**FCC Class II PC request letter  
DP AUDIO VIDEO LLC**

Attn: OET Dept.  
Ref: FCC Class II Permissive change for FCC ID:2AVRVPKBT300  
Applicant:DP AUDIO VIDEO LLC

This is to request a Class II Permissive change for FCC ID:2AVRVPKBT300 originally granted on 03/01/2022 (date).

Changes : 1. The new product has Changed the internal battery.

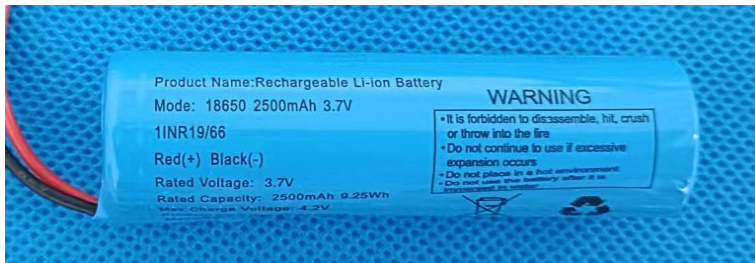
Original:

New

Changes : 2. The new product has changed charging IC.

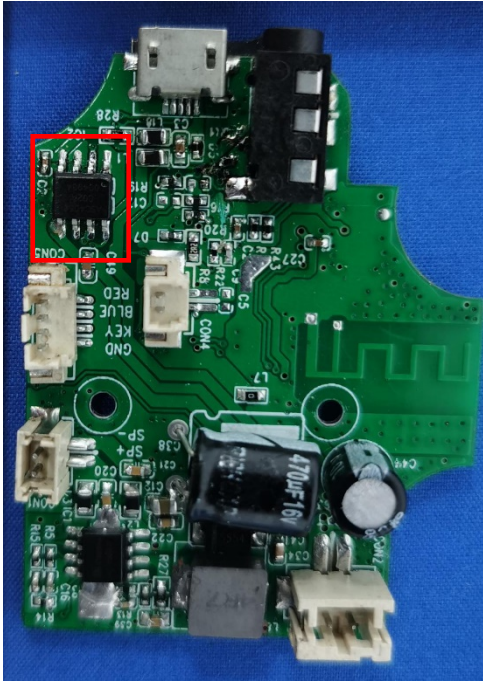
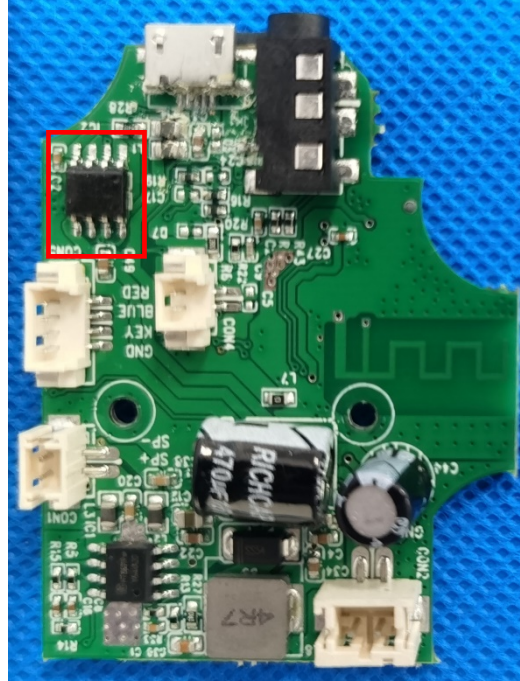
Original:

New:
